**Re: Comments on “Final” Set of Plans**  
Farm Road Homes Project  
55-65 Farm Road  
Sherborn, MA

**Scott Horsley**  
**Groundwater Mounding and Nitrate Loading Analyses**

Mr. Brian Moore  
49 Farm Road  
Sherborn, MA  
Re: Farm Road 40B, Sherborn, MA

Table 3.1 - SAS Soil Testing Summary

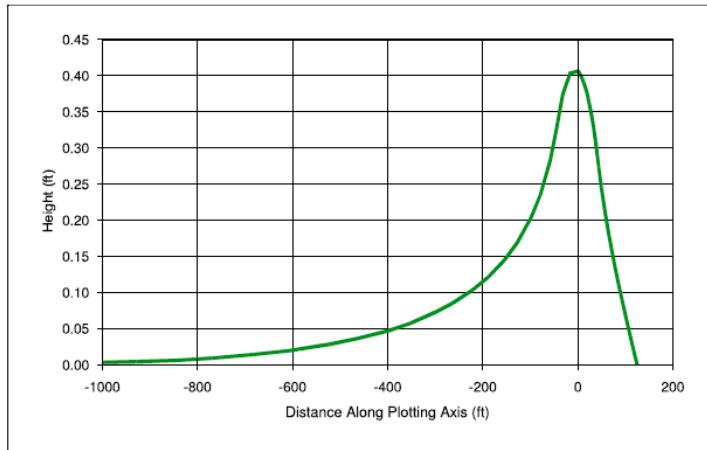
In fact, the actual test pit data provided by CLWE shows only a saturated thickness of 3.96 feet. Table 3.1 from the Hydrogeologic Evaluations Report (shown below) summarizes the test pit data and shows the estimated seasonal high groundwater (ESHGW) or water table and the bottom of hole (test pit) – the difference is the measured saturated thickness. Although I agree that there is likely to be additional saturated thickness beneath the test pit elevations, the selection of 14.5 feet or 20 feet (later in the report) as a saturated thickness is not supported by the data.

Note: 1. Nearby downgradient wetland is at elevation of 177-178, which is in line with the weeping water elevation in Test pits DHTP-11An and DHTP-10An; 2. Except the two test pits, other test pits were dry and no water measured and the water table based on the depth of hole is a conservative estimate and normally will not be considered.

### **3. Suggested Revisions to Groundwater Mounding Analysis**

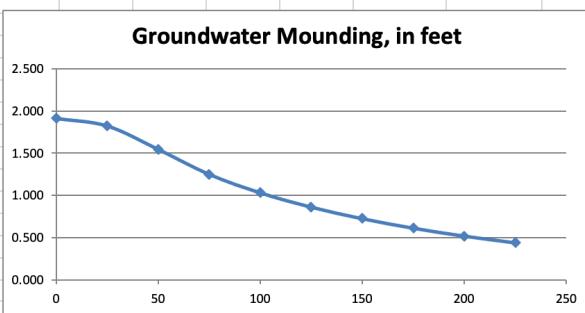
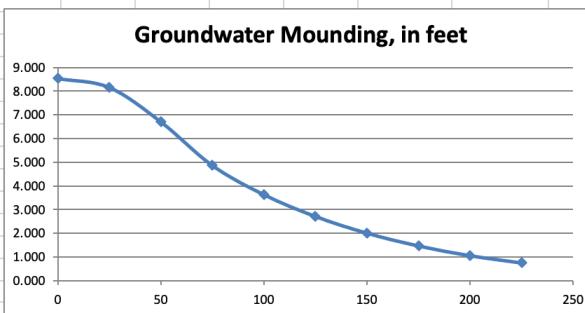
I have re-run the groundwater mounding model (Hantush) using more conservative values for hydraulic conductivity and saturated thickness but maintaining other inputs to the model in accordance with CLWE’s estimates. Because there are no available in-situ permeability tests (as recommended by MADEP) I selected the most conservative hydraulic conductivity values presented in CLWE’s Table S3 (shown below). I assumed a saturated thickness of 8 feet (twice the value that CLWE measured).

The results of the modelling shows significant groundwater mounding directly underneath the wastewater disposal field at 1.9 feet and 0.7 feet at the wetland. The results at the stormwater infiltration facility indicate groundwater mounding of 8.5 beneath the system and 2.0 feet at the wetland boundary. To my knowledge CLWE has not reported on groundwater mounding at the stormwater infiltration facility.

My analyses indicate that the groundwater mounding associated with the stormwater and wastewater facilities will overlap causing cumulative impacts. They need to be evaluated together. The stormwater mounding will redirect (or push) the wastewater effluent further south in the direction of the private wells on neighboring properties. The CLWE analysis does not provide groundwater mounding for the stormwater facility and clearly does not address the cumulative impacts between the stormwater and wastewater facilities.

Figure 4 – Areas of Impact

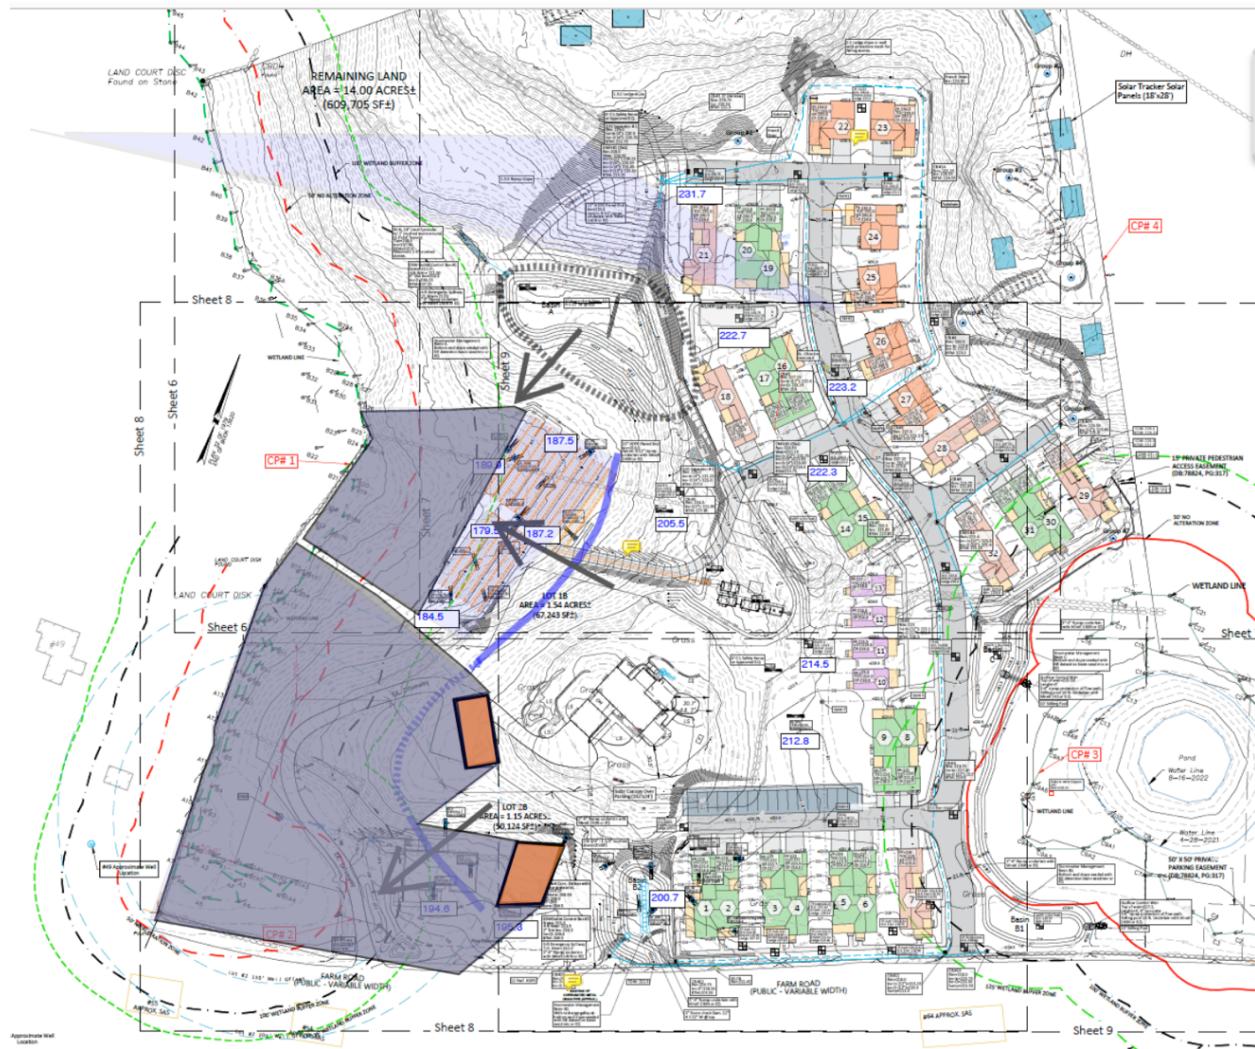
To determine groundwater flow directions on the subject property I plotted existing groundwater elevations provided by the applicant's consultant, Creative Land and Water Development. A series of test pits shown on the site plans provide estimated seasonal high groundwater (ESHGW) elevations. Utilizing this data I constructed a water table map (highlighting the 195-foot contour) which indicates groundwater flow in a westerly direction.

Based upon these groundwater flow directions I delineated two Areas of Impact (AOI). The northerly AOI is downgradient of the proposed 40B development septic system and the southerly AOI is downgradient of septic systems on two adjacent lots. The locations of the septic systems are shown on a basemap prepared by Creative Land Development dated September 28, 2023 (see figure 4).

I then calculated the resulting nitrogen concentrations at the downgradient property boundary adjacent to your parcel (see Table 1). I applied an average wastewater concentration of 35 mg/liter for Title 5 systems on the two adjacent lots and a concentration of 19 mg/liter for a potential innovative and alternative (I&A) septic system at the 40B project site.

This analysis indicates that the proposed wastewater discharges will result in nitrate-nitrogen concentrations in excess of state and federal drinking water standard of 10 mg/liter for nitrate-nitrogen at the property boundary of your land. There is an additional drinking water well on the adjacent lots within the Area of Impact that will also be degraded by the wastewater discharges.
